# Access Compliance Report

## Public Rights-of-Way

Intersection ID: 11981	Main Street: W_6TH_ST	Cross Street: N_CHURCH_ST	Location: E
ADA ID: 9EE7B8937E5B	Ramp Type: PerpDiag	Initial Pass/Fail: Fail	Overall Compliance: No
Severity Score: 48.75			
Codes/Mitigation Info/Possible Solution		Field Measurements/Component Compliance

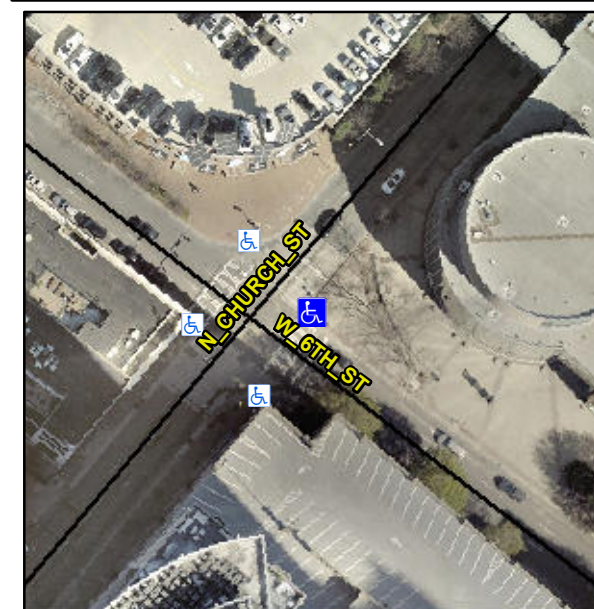
**Not Found, R304.5.1, R304.2.2, R304.5.3**

Compliance	Description	Data	Compliance	Description	Data
N/A	Ramp Length (in)	35.0	No	Ramp Slope (%)	10.1
No	Ramp Width (in)	31.0	No	Ramp XSlope (%)	3.6
N/A	Flare Type LT	N/A	N/A	Flare Type RT	N/A
N/A	Flare Slope LT (%)	N/A	N/A	Flare Slope RT (%)	N/A
N/A	Flare Traversable LT?	N/A	N/A	Flare Traversable RT?	N/A
N/A	Landing Length (in)	N/A	N/A	DWS Provided?	N/A
N/A	Landing Width (in)	N/A	N/A	DWS Contrast?	N/A
N/A	Landing Slope (%)	N/A	N/A	DWS Length (in)	N/A
N/A	Landing X Slope (%)	N/A	N/A	DWS Full Width?	N/A
N/A	Landing Curb? (Y/N)	N/A	N/A	DWS Offset (in)	N/A
N/A	Shared Landing?	N/A			
N/A	Gutter Ponding?	N/A	N/A	Gutter Slope (%)	N/A
N/A	Gutter Lip Ht (in)	N/A	N/A	Gutter X Slope (%)	N/A
N/A	Painted X Walk1?	Yes	N/A	Painted X Walk2?	Yes
	X Walk 1 Direction	To NW		X Walk 2 Direction	To SW
N/A	X Walk 1 Width (in)	114.0	N/A	X Walk 2 Width (in)	112.0
	X Walk 1 Slope (%)	0.4		X Walk 2 Slope (%)	0.1
	X Walk 1 X Slope (%)	2.0		X Walk 2 X Slope (%)	1.9

**Remove & Replace Curb Ramp With Two New Directional Ramps or Equivalent.**
